S4.55(2) MODIFICATIONS - GROUND LEVEL

NEW HOSPITALITY VENUE  
PARRAMATTA  
FOR CASTLE HILL RSL CLUB

TITLE  
GROUND FLOOR PLAN

S4.55(2) MODIFICATIONS - FIRST FLOOR

#### S4.55(2) MODIFICATIONS - ELEVATIONS

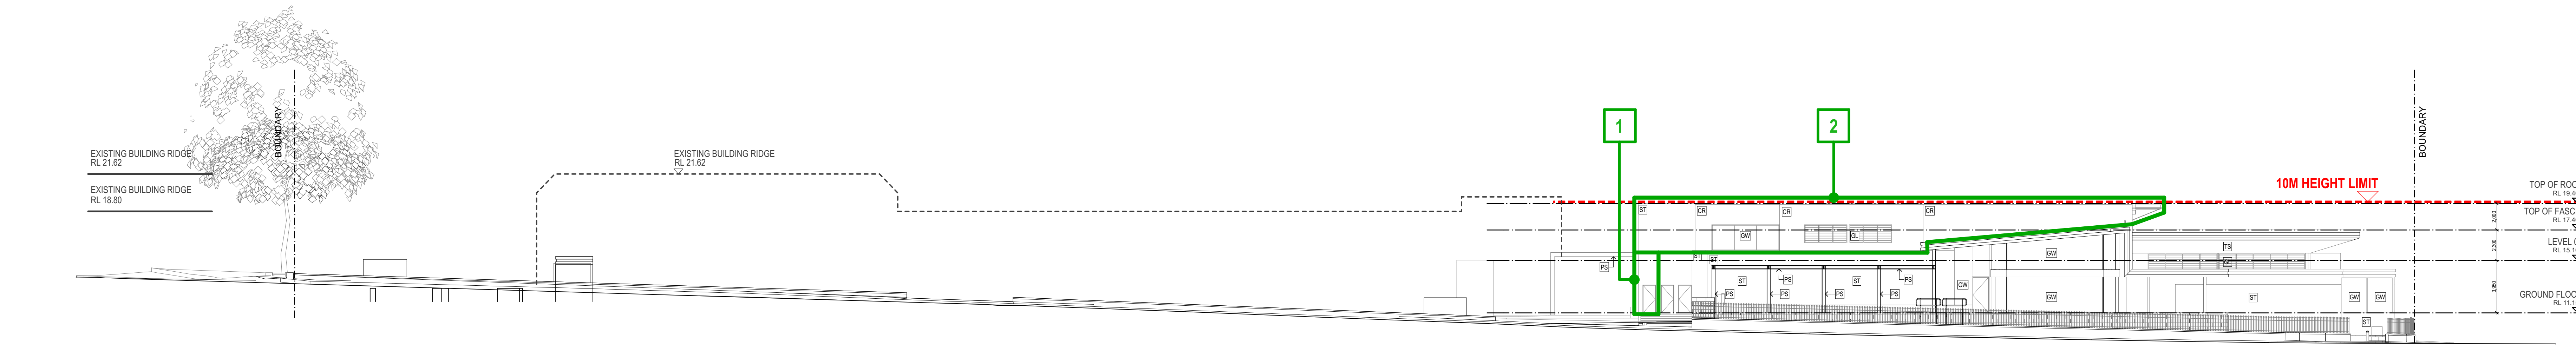
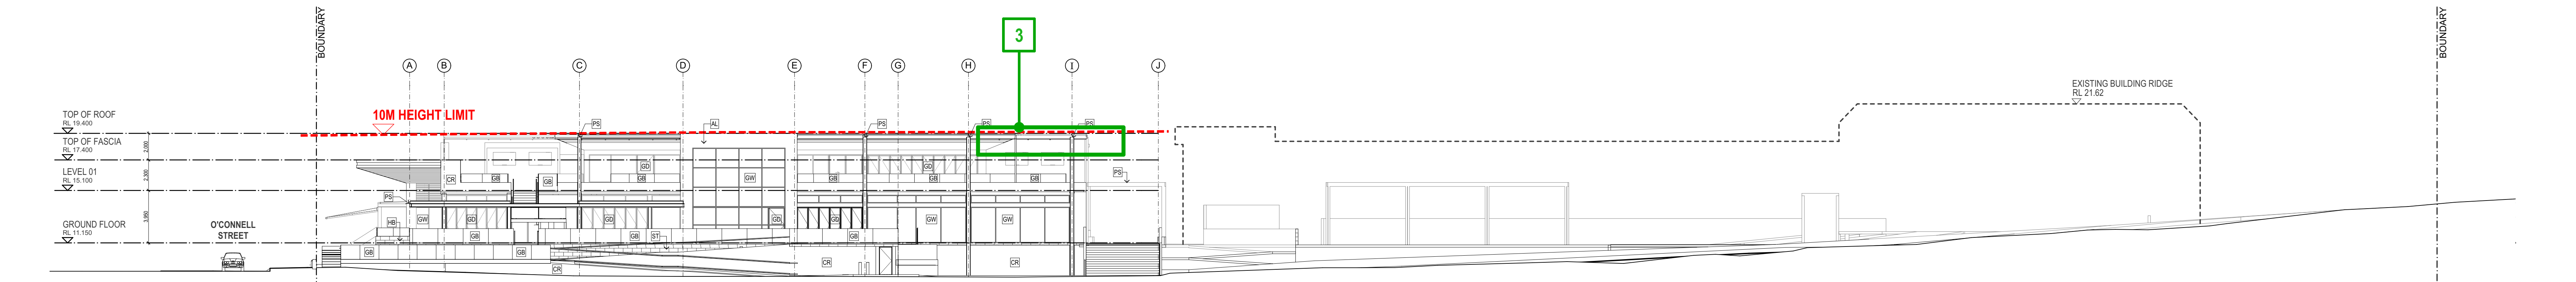
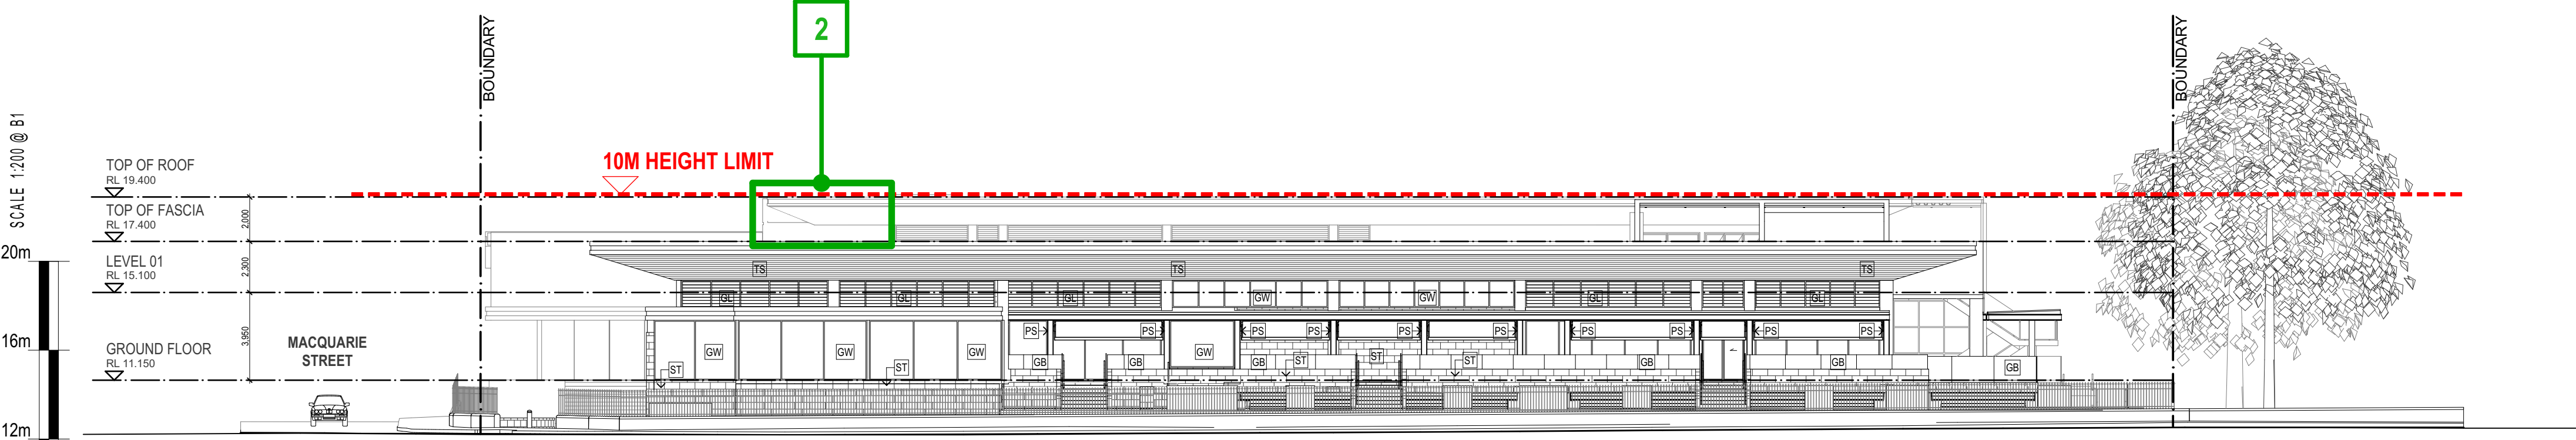
- MODIFICATION OF EGRESS STAIR FROM GROUND LEVEL TO FIRST FLOOR TO SERVICE NEW FUNCTION ROOMS.
- FIRST FLOOR EXTENSION TO ACCOMMODATE FUNCTION ROOMS
- EAVES REMOVED, EXTERNAL WALL RAISED TO FORM PARAPET

**S4.55(2) MODIFICATIONS - SECTIONS**

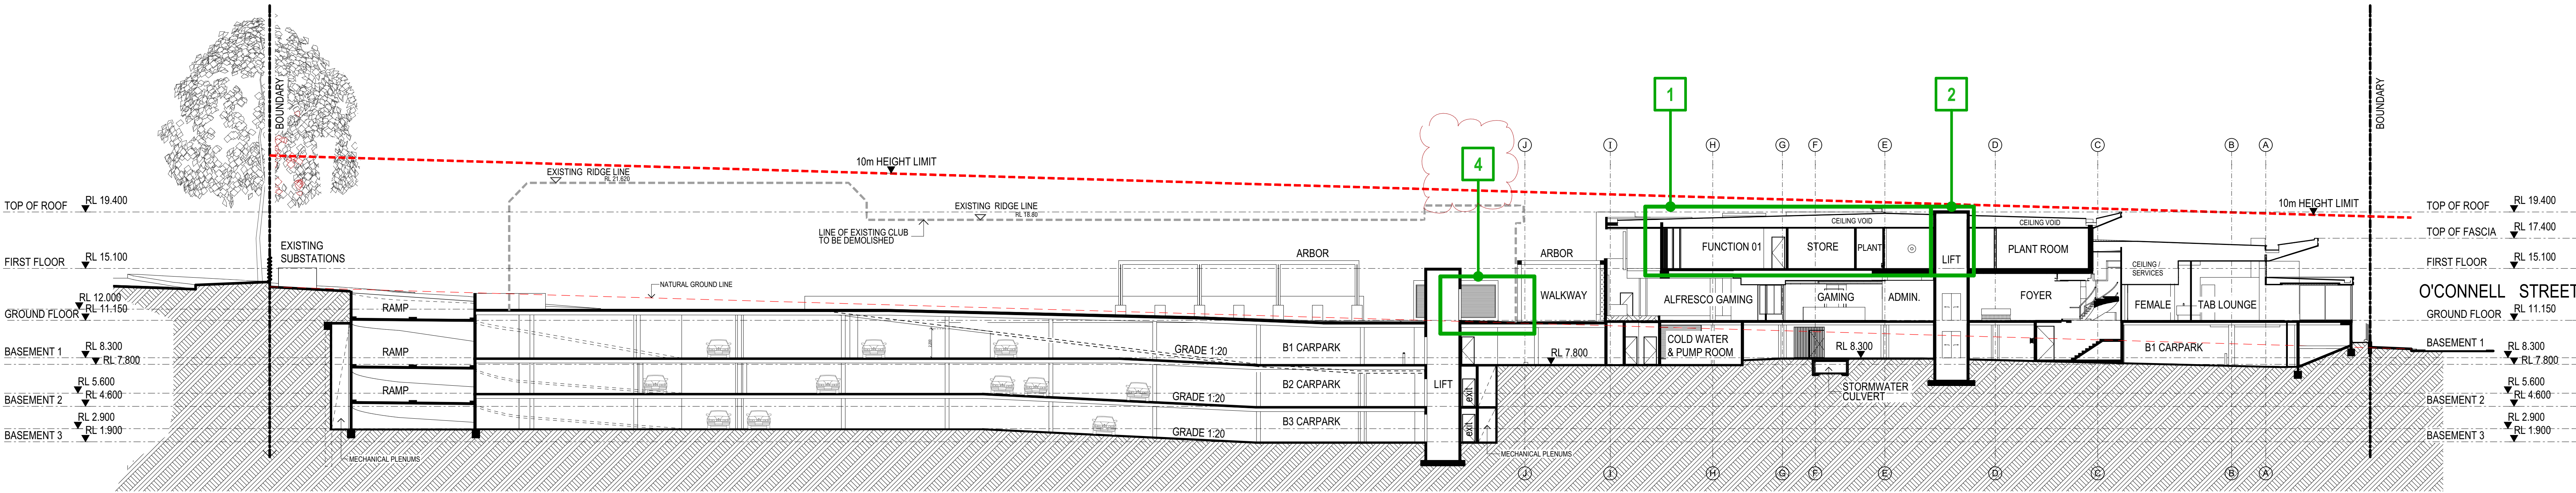
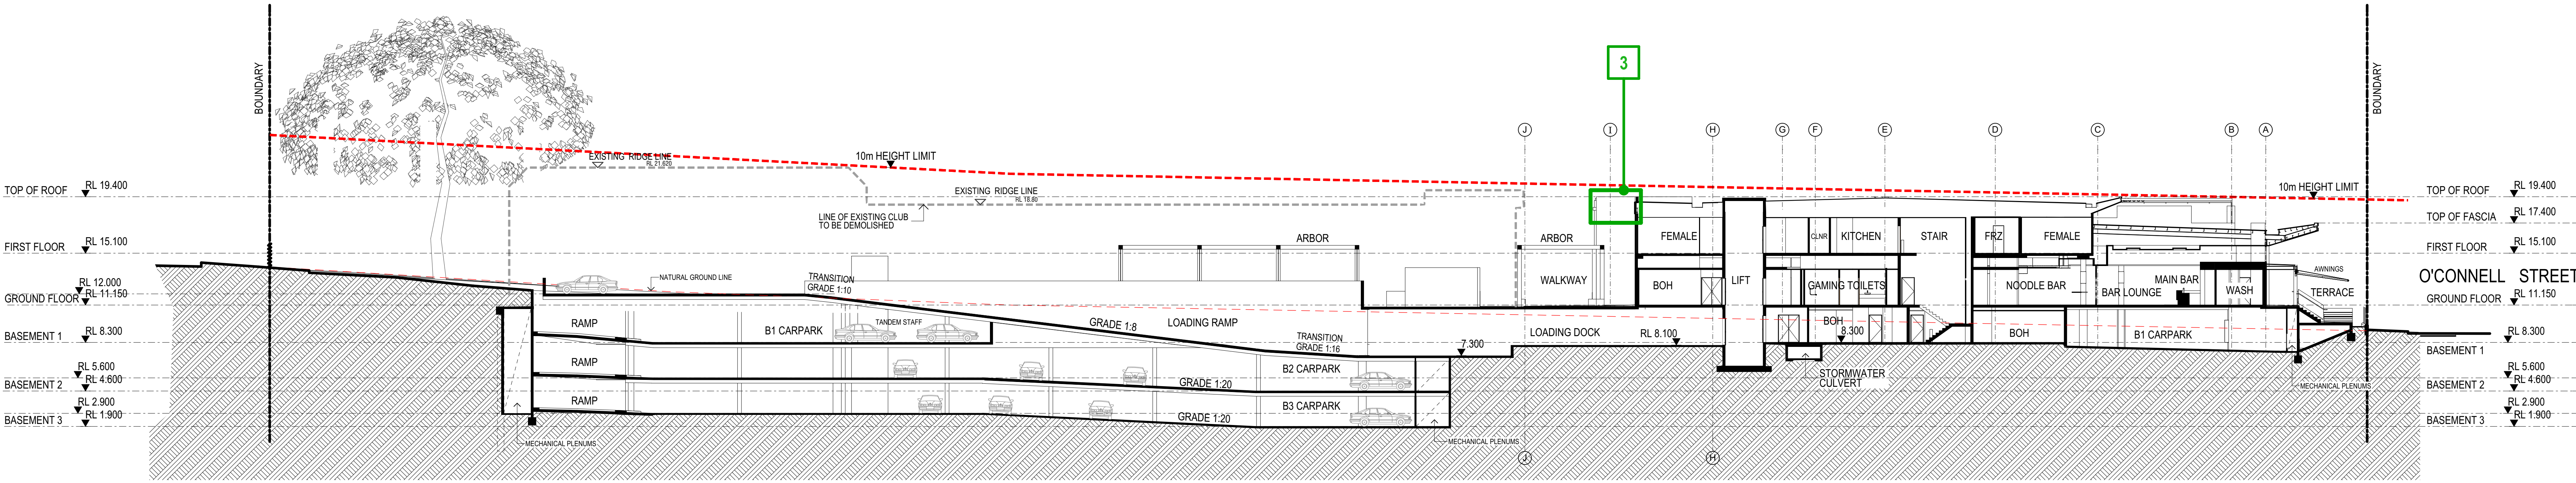
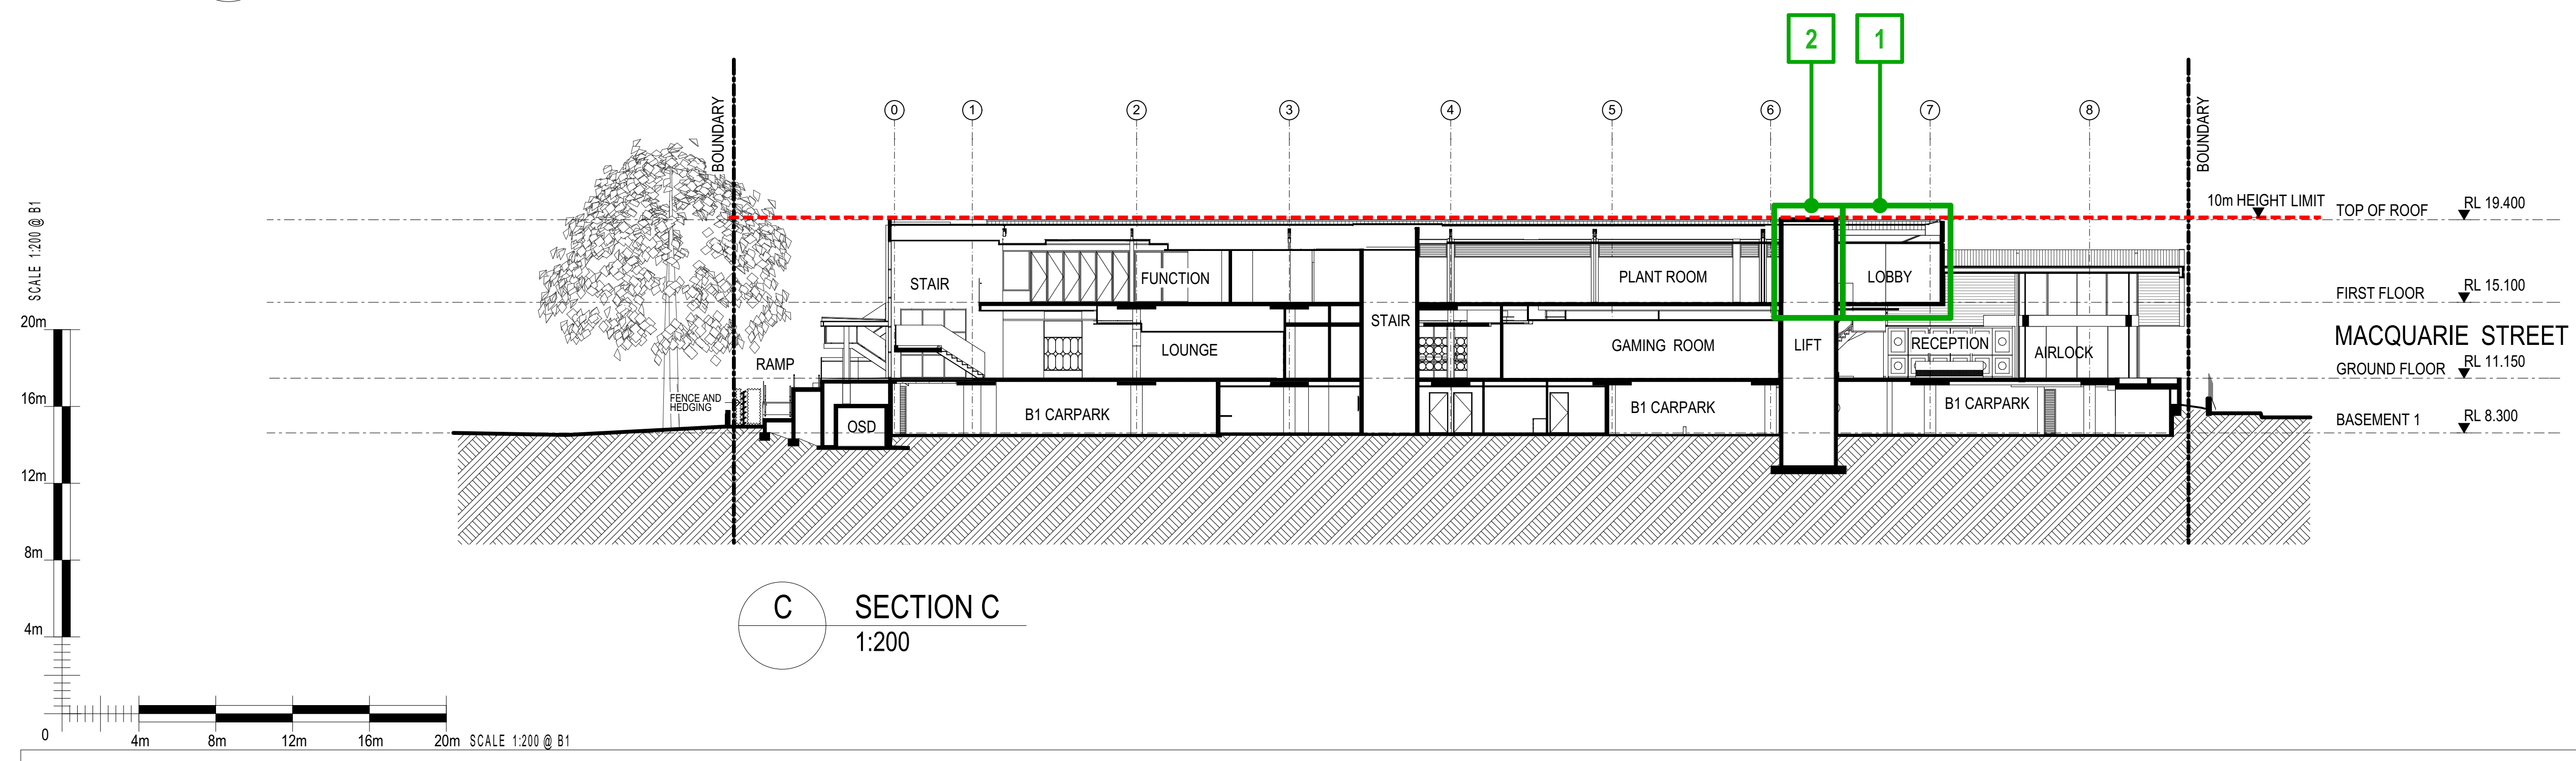
1. FIRST FLOOR EXTENSION TO ACCOMMODATE FUNCTION ROOMS
2. LIFT EXTENDED TO SERVICE FIRST FLOOR.
3. EAVES REMOVED, EXTERNAL WALL RAISED TO FORM PARAPET
4. RAISING THE PENETRATIONS TO THE STAGE 2 CAR PARK UP TO RL 11.150
